Stormwater Quality Plan Information Sheet and Inspection Fee Schedule

Project Name: Coors & Western Trail Tract 3A

**RE: RESPONSE TO STORMWATER QUALITY COMMENTS
ATIVO ALBUQUERQUE LLC – 4500 QUAKER HEIGHTS
EROSION AND SEDIMENT CONTROL PLAN**

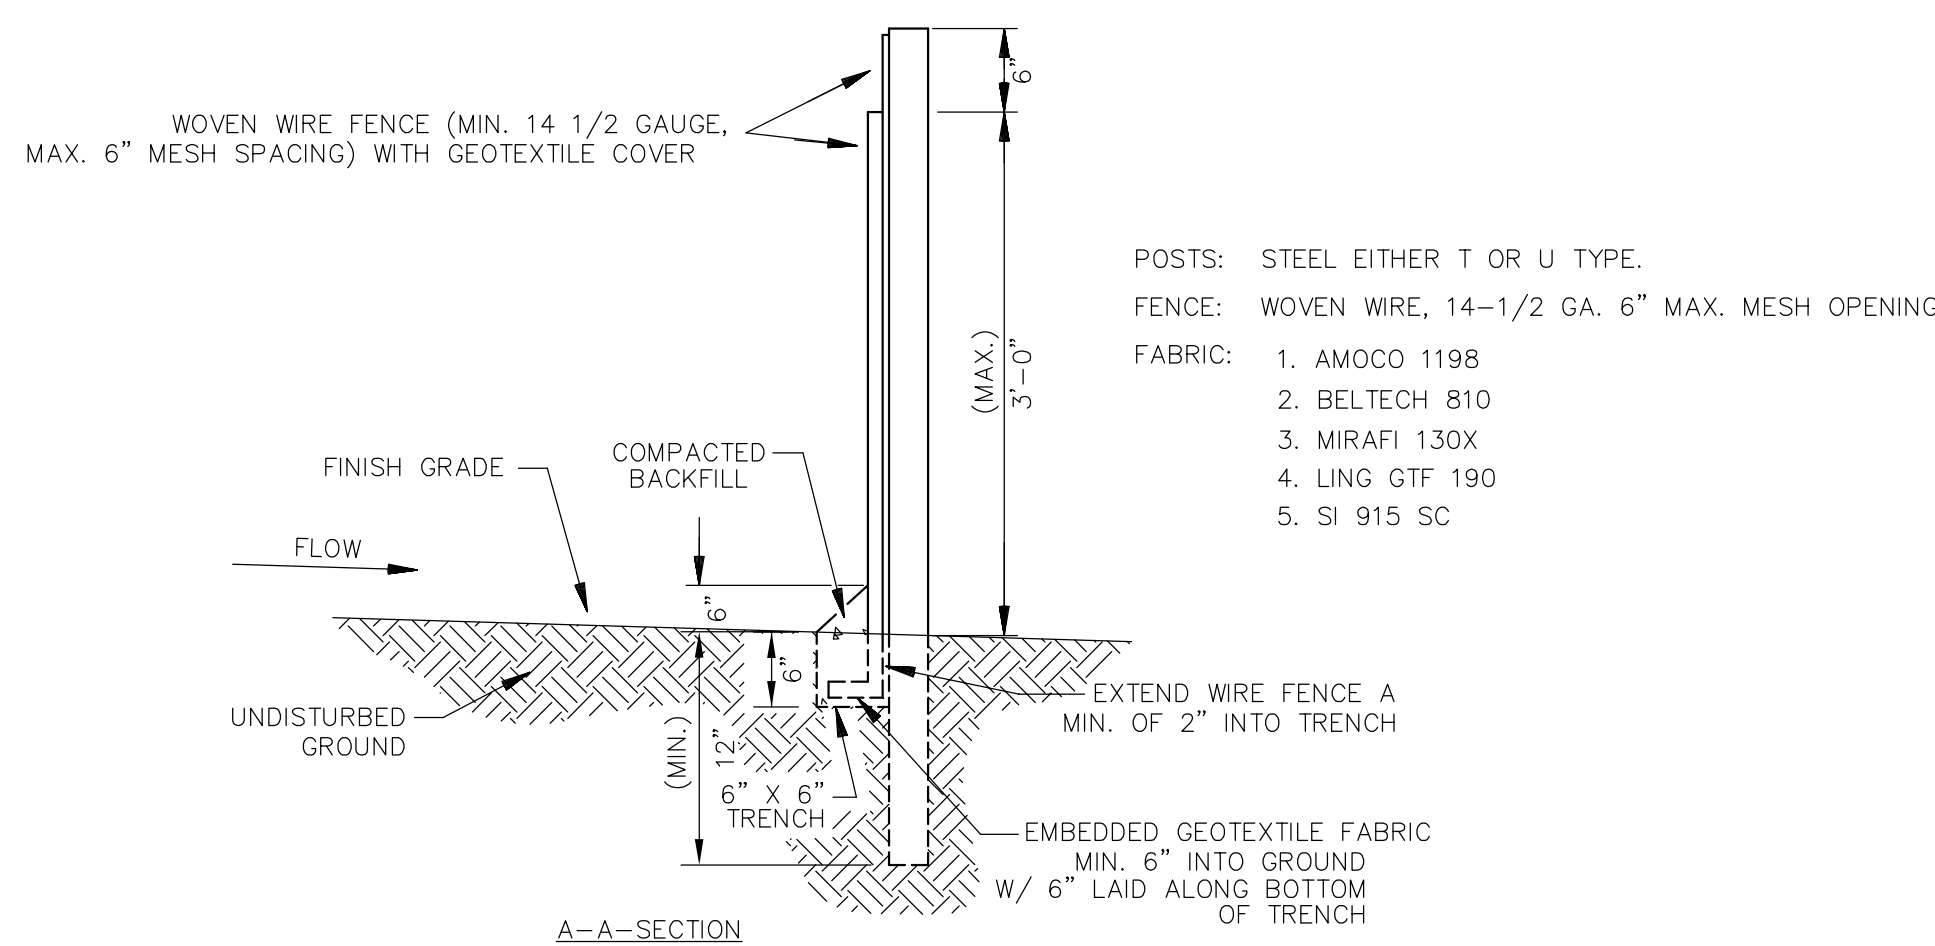
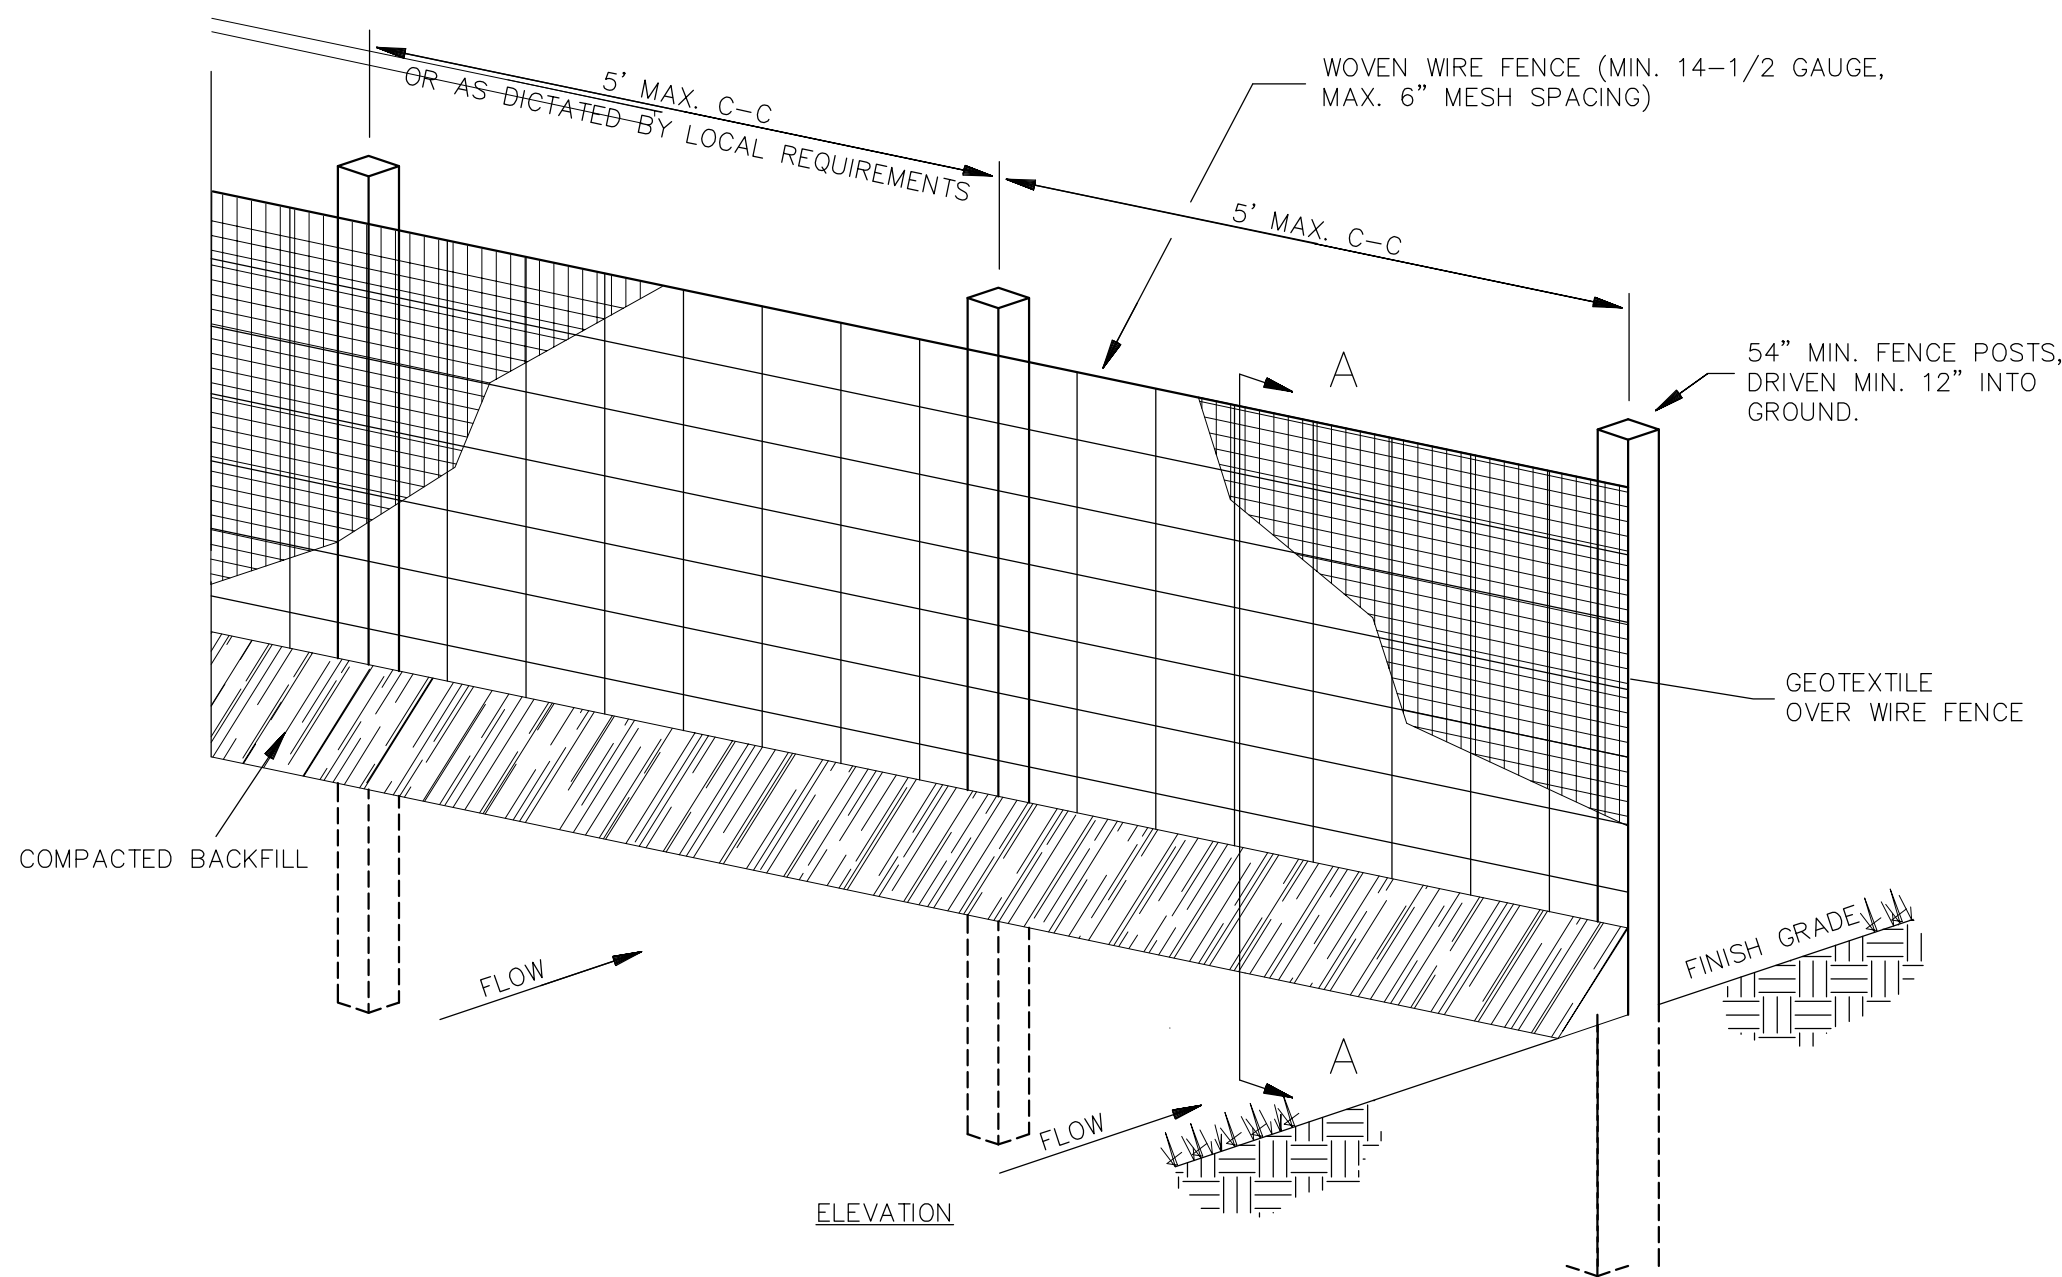
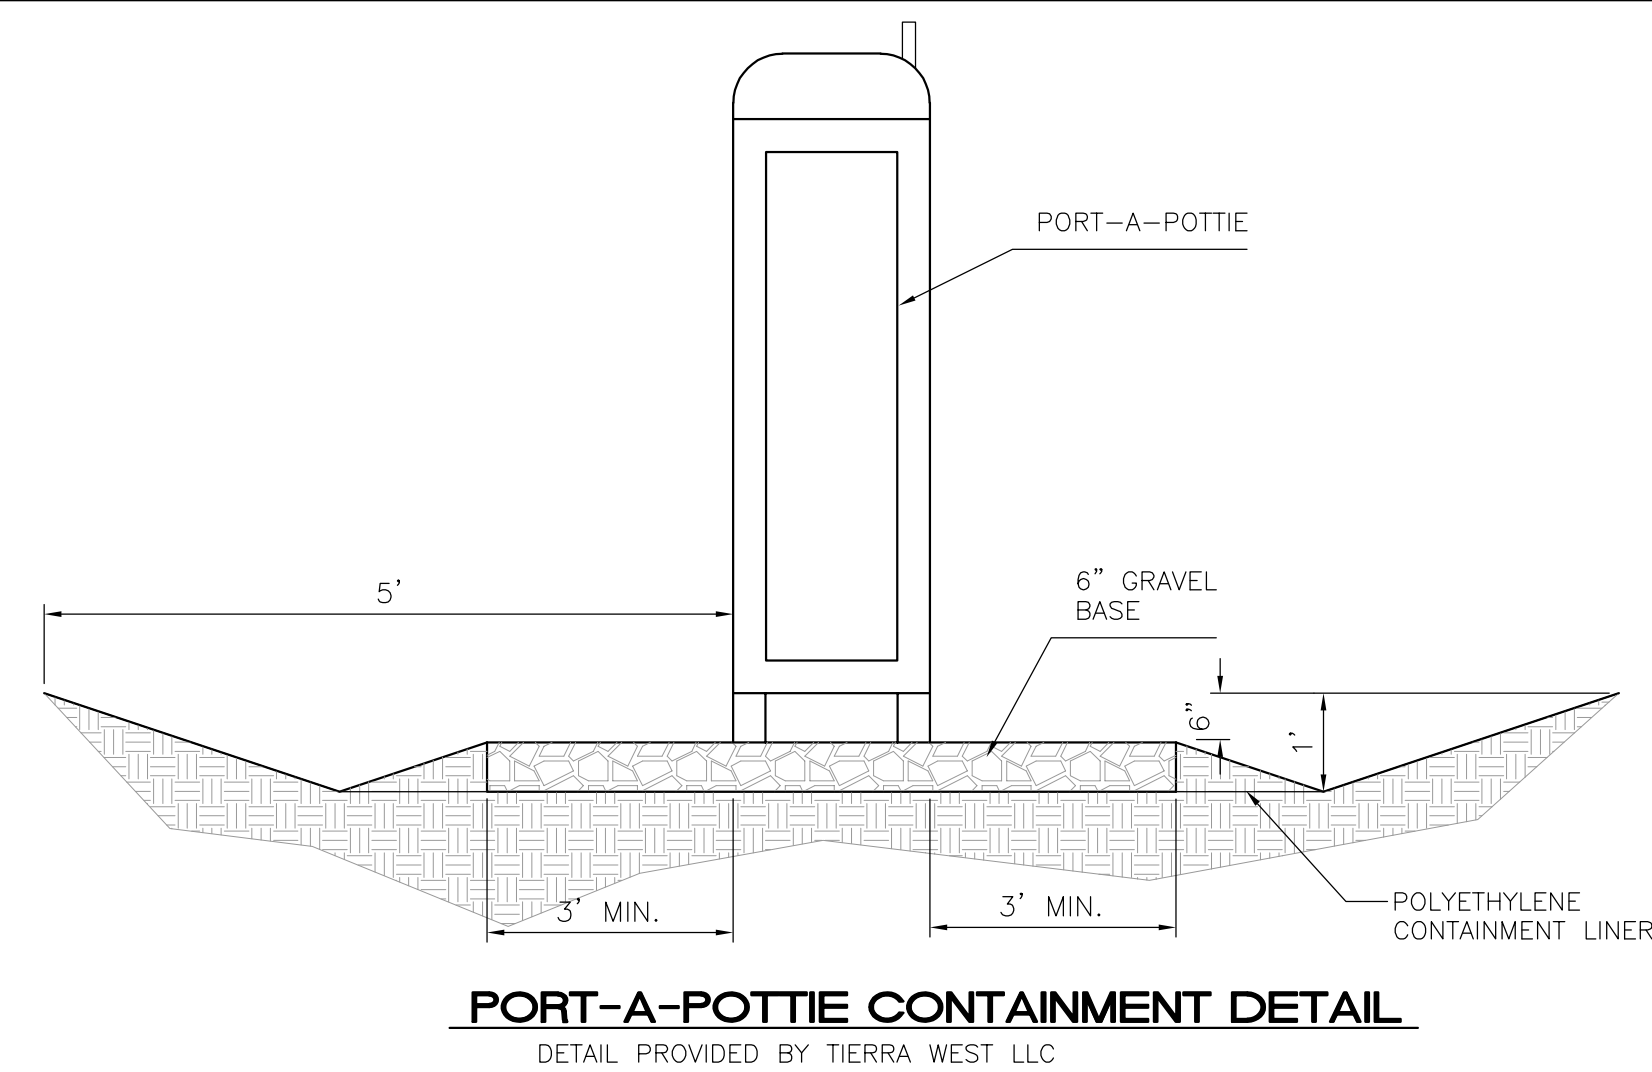
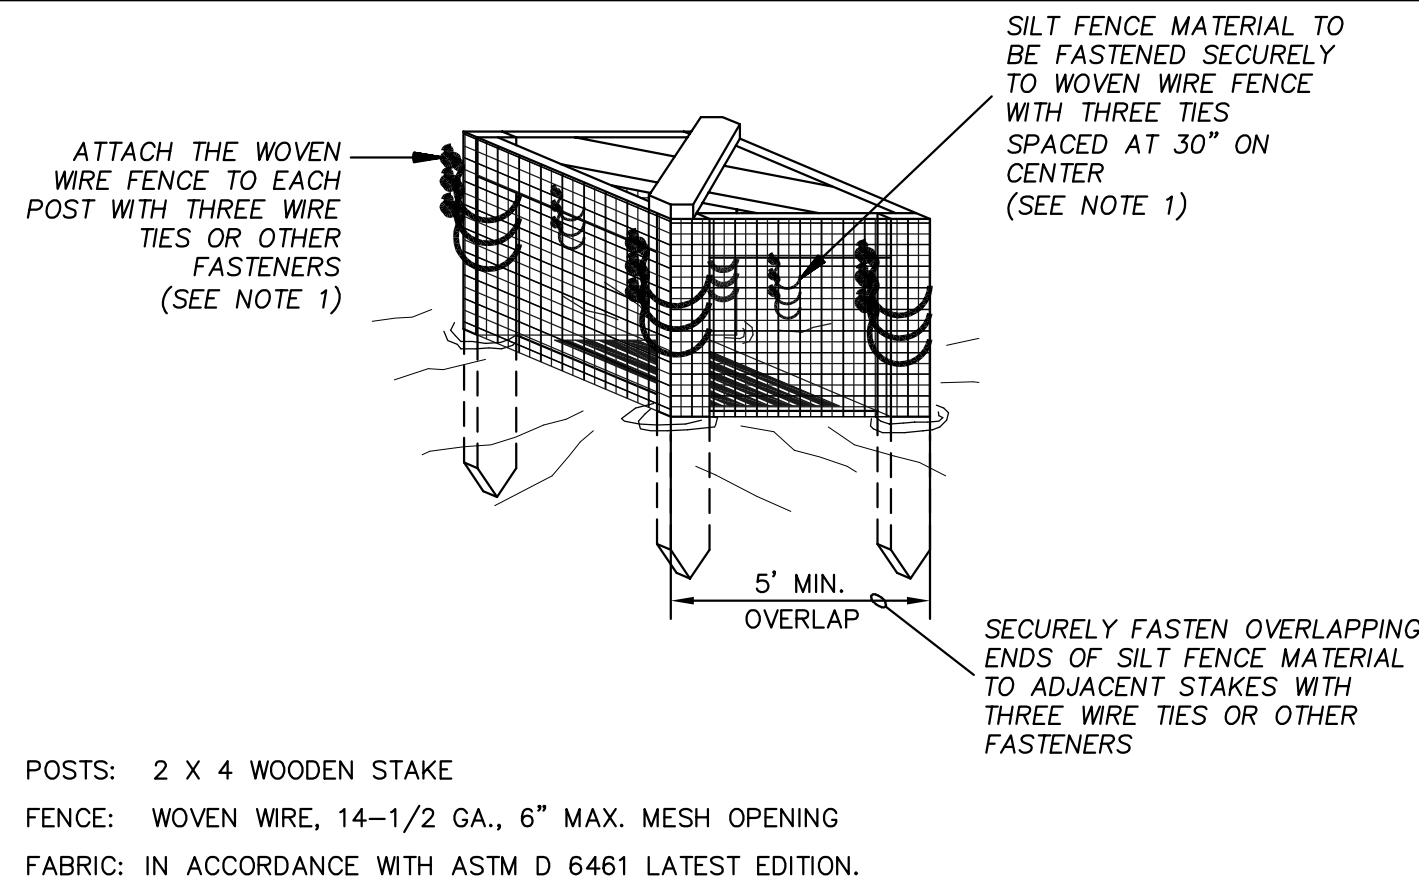
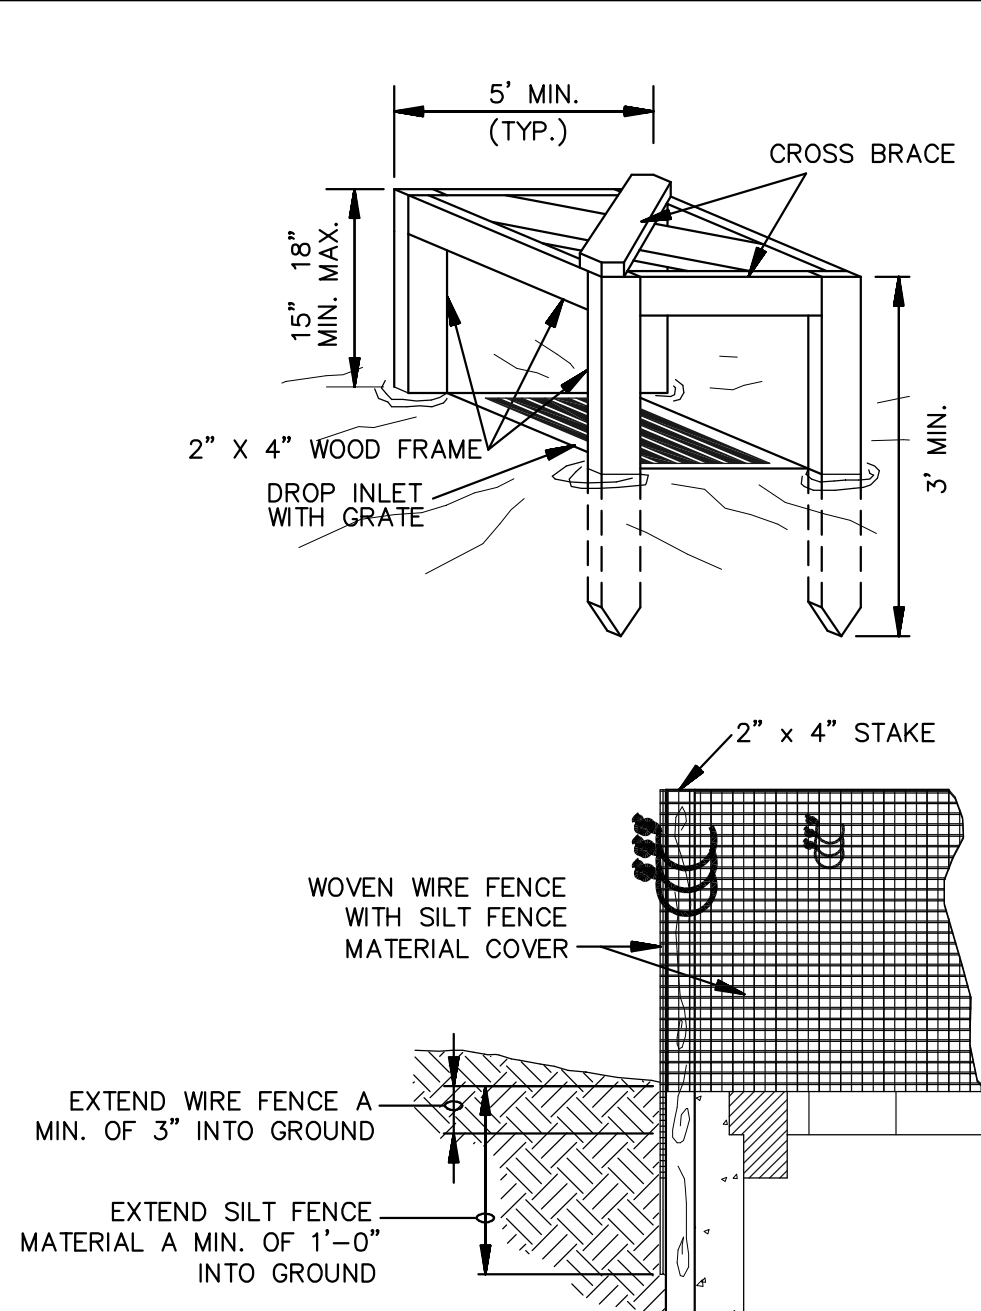
1. The "limits of disturbance" symbol in the legend is not shown anywhere on the plan. Clearly indicate the limits of disturbance. (CGP7.2.4.b.i)
Response: The limits of disturbance are now shown on the plan with line work matching that of the legend.

Response: The site plan is being included in this ESC Plan resubmittal package.
3. Describe undisturbed and pre-construction ground cover (CGP7.2.4.e)
Response: A "Undisturbed and Pre-Construction Ground Cover" note has been added to the plan for describing existing ground cover.

4. List operators on the plan, including name, phone #, and e-mail address. Include the developer/property owner's representative authorized to make changes to contract documents, plans, and specifications per CGP 7.2.1. If there are multiple operators describe the area of control for each. State whether the operators will share a SWPPP or if they will each have separate SWPPPs

Response: The operators (the owner and contractor) are now listed on the plan with contact information.
5. Identify stormwater team members responsible for sediment removal, BMP maintenance, and inspections on the plan, including name, phone #, and e-mail address (CGP 7.2.2). Provide the stormwater team for each operator

Response: A stormwater team members list has been added to the plan with contact information.
6. Describe the nature and extent of construction activities for each operator (CGP7.2.2.), including a) nature of construction activities, b) size of the property, c) size of disturbed area, d) description of construction support activities, and e) size of maximum disturbed area.

8. Soil information – add a table with name type, particle sizes, and Erodibility factor (CGP 2.1.1).

10. City Standard ESC Notes attached.

Response: This information has been added to the plan.

Response: A soil information sheet has been added to the plan for providing this information.

Response: These notes have been added to the plan.
